Description of designer's work <b>HEAT LOSS / GAIN CALCULATIONS DUCT SIZING RESIDENTIAL MECHANICAL VENTILATION DESIGN SUMMARY RESIDENTIAL SYSTEM DESIGN per CSA-F280-12</b>		<b>Model:</b> 2010 <b>Mill Pond</b> <b>Project:</b> CENTREFIELD (WEST GORMLEY)	
<b>D. Declaration of Designer</b>			
I, <u>MICHAEL O'ROURKE</u> (print name)		declare that (choose one as appropriate):	
<input type="checkbox"/> I review and take responsibility for the design work on behalf of a firm registered under subsection 3.2.4. of Division C, of the Building Code. I am qualified, and the firm is registered, in the classes/categories. Individual BCIN: _____ Firm BCIN: _____		<input type="checkbox"/> I review and take responsibility for the design and am qualified in the appropriate category as an "other designer" under subsection 3.2.5. of Division C, of the Building Code. Individual BCIN: <u>19669</u> Basis for exemption from registration and qualification: _____ O.B.C. SENTENCE 3.2.4.1 (4)

## HVAC REVIEWED

SITE NAME: CENTREFIELD (WEST GORMLEY)  
BUILDER: ROYAL PINE HOMES

**RESIDENTIAL MECHANICAL VENTILATION DESIGN SUMMARY**

BASEMENT PLAN, EL. 'A' & 'B'

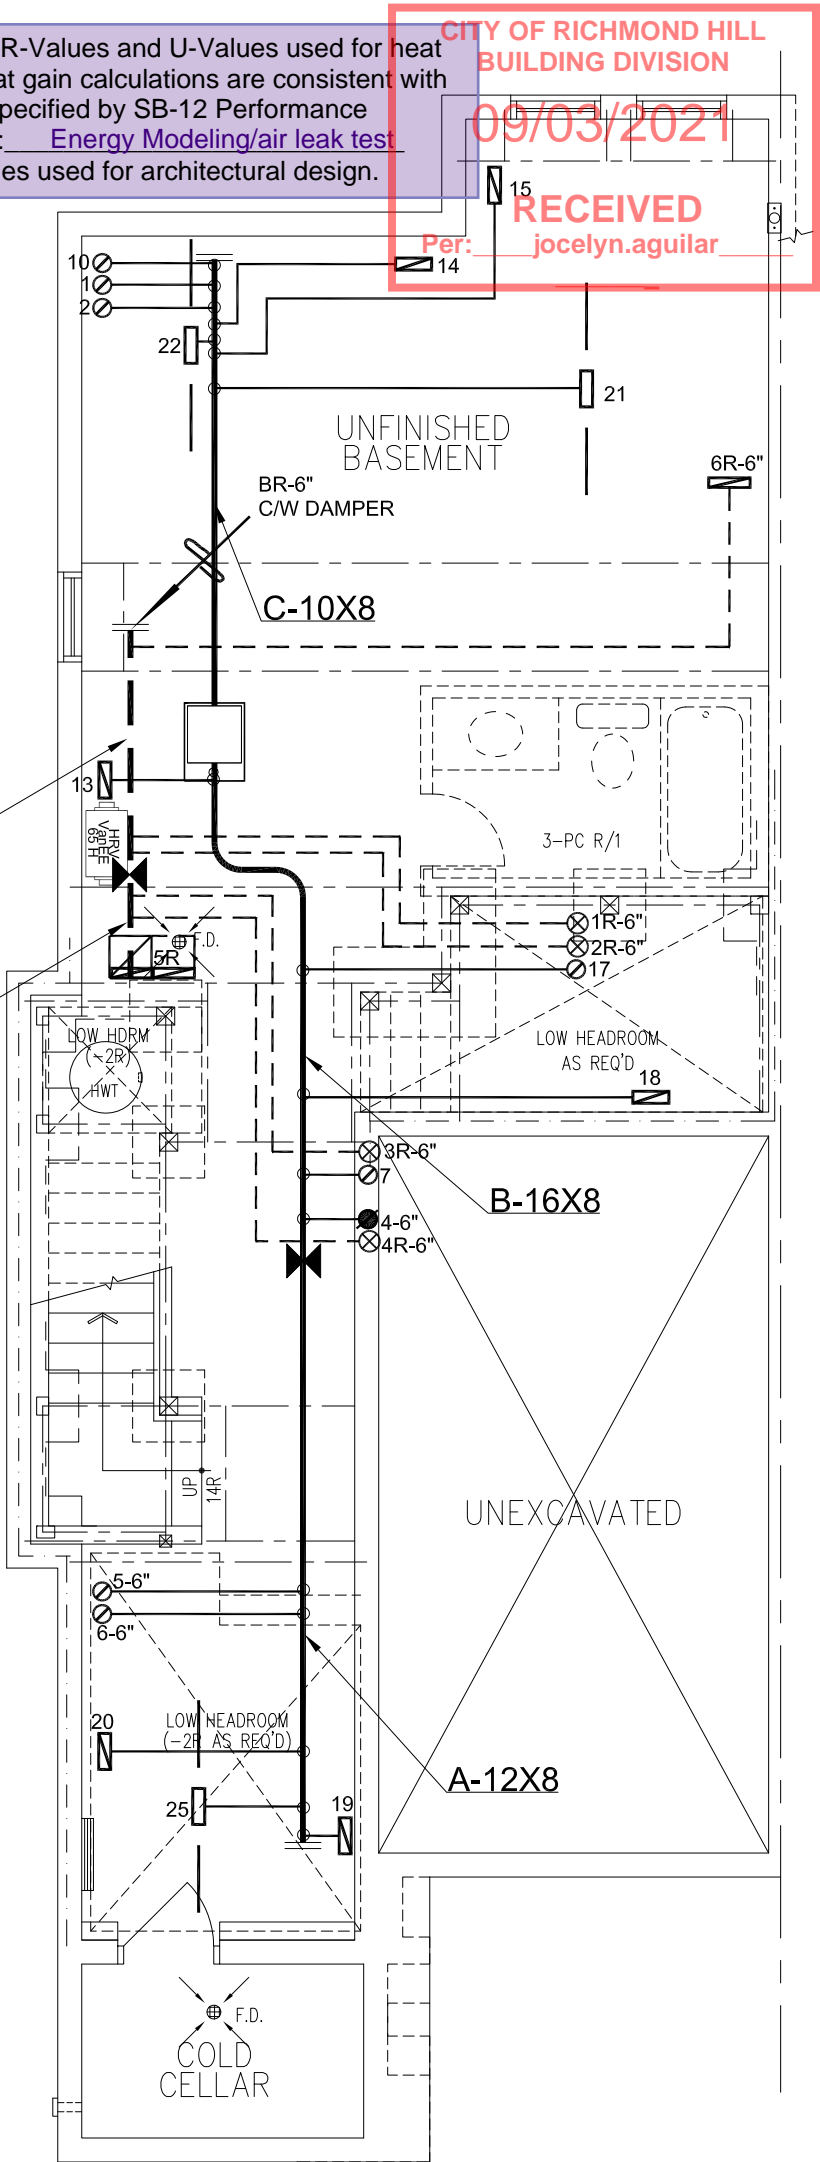
Exterior insulation effective R-Value for wall, roof or exposed floor shall be maintained at the respective location where duct or sanitary pipes are routed inside exterior envelope.

Ensure that R-Values and U-Values used for heat loss and heat gain calculations are consistent with the values specified by SB-12 Performance Compliance: Energy Modeling/air leak test and the values used for architectural design.

Minimum R-12 Insulation Value required for ducts installed at unheated or exposed condition (OBC 2012 Div.B 6.2.4.3(10) and seal the ducts as per 6.2.4.3(11) & HRAI Digest 2005, Clause 4.5.

Penetration of Air Barrier System by ducts, wires, conduits or building materials shall be sealed as per OBC 2012, Div.B 9.25.3.3.(9) & (10).

HRV Unit shall be energy qualified complete with sealed and insulated connection to outdoor vent hoods per Energy Star Technical Specification 4.7.1.2. When HRV is used as principal fan, the controller shall be wired to the HRV Unit and interconnected to the furnace fan. HRV shall be designed for operation at outside temperature of -25°C and a flow of minimum 30 L/s (64 CFM)

Volume control dampers to all branches to be installed per OBC 2012, Div.B, 6.2.4.5.

Space between studs and joists used as return ducts shall be separated from unused portion as per OBC 2012 Div.B 6.2.4.7(6)

Combustion air supply shall be provided to the furnace and hot water tank.

HRV duct connection shall be in compliance with OBC 2012 Div.B 9.32.3.6(3) & 9.32.3.4(7).

HRV installation, testing, startup and commissioning shall be in compliance with OBC 2012, Div.B 9.32.3.11, 9.32.3.11(7)&(10)

Supply air grill at finished basement shall be at low level. Return air grill for finished or unfinished basement shall be at low level. HRAI digest 2005, clause 7.7(3).

Air supply outlet shall not be installed on a furnace plenum or trunk duct. (HRAI Digest 2005, 4.6)

Exterior insulation effective R-Value for wall, roof or exposed floor shall be maintained at the respective location where duct or sanitary pipes are routed inside exterior envelope.

PART. GROUND FLOOR PLAN  
- OPT. KITCHEN LAYOUT

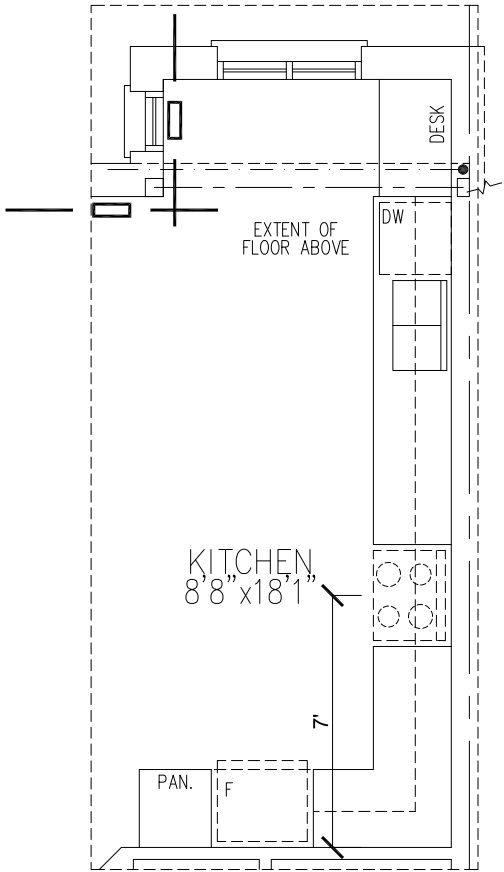
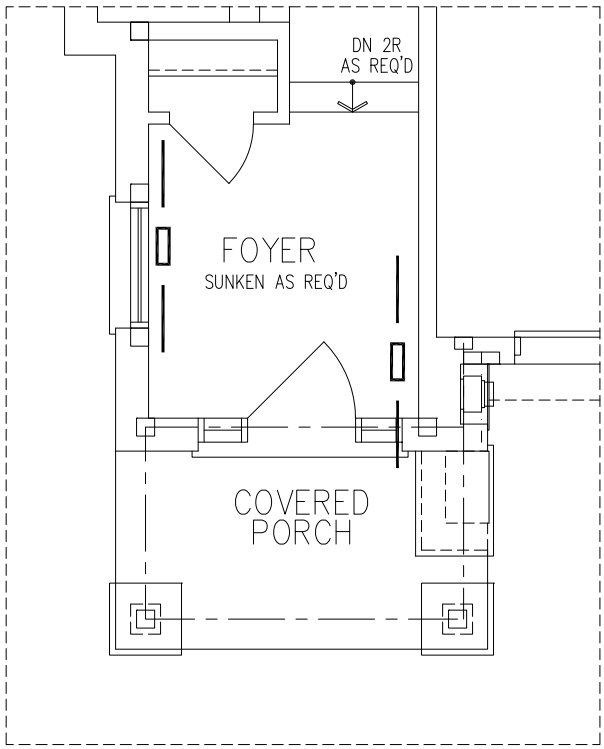
Space between studs and joists used as return ducts shall be separated from unused portion as per OBC 2012 Div.B 6.2.4.7(6)

Exterior insulation effective R-Value for wall, roof or exposed floor shall be maintained at the respective location where duct or sanitary pipes are routed inside exterior envelope.

Kitchen hood exhaust duct shall be provided as per OBC 2012, Div.B 9.32.3.10, 9.32.3.5(2).

SECOND FLOOR PLAN, EL. 'B'

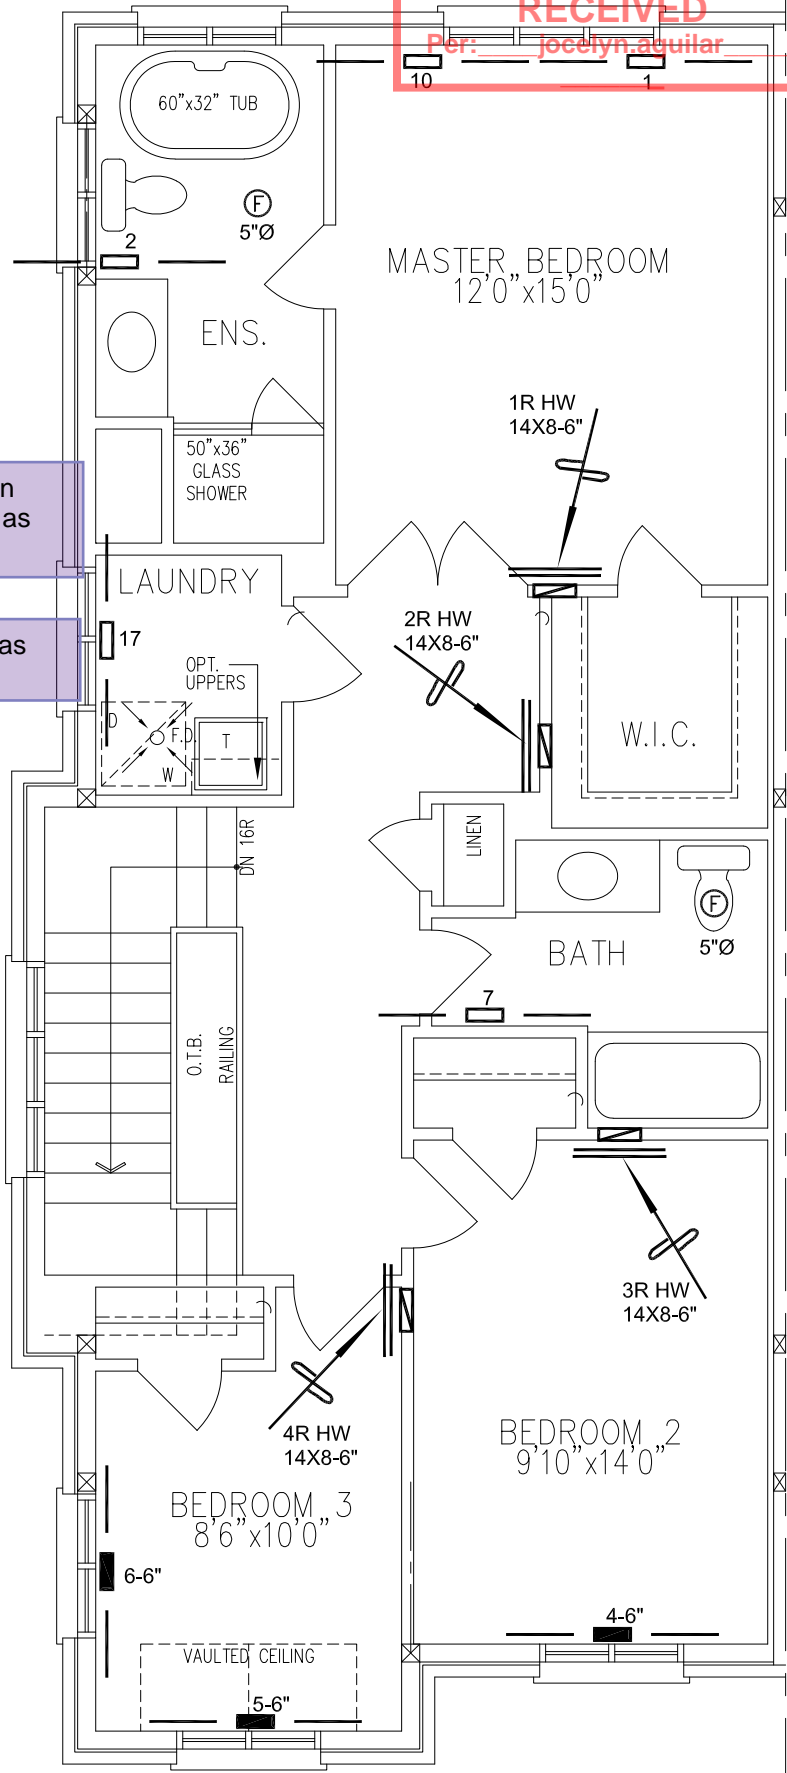
Space between studs and joists used as return ducts shall be separated from unused portion as per OBC 2012 Div.B 6.2.4.7(6)

Laundry dryer exhaust duct shall be provided as per OBC 2012 Div.B 6.2.3.8(7).
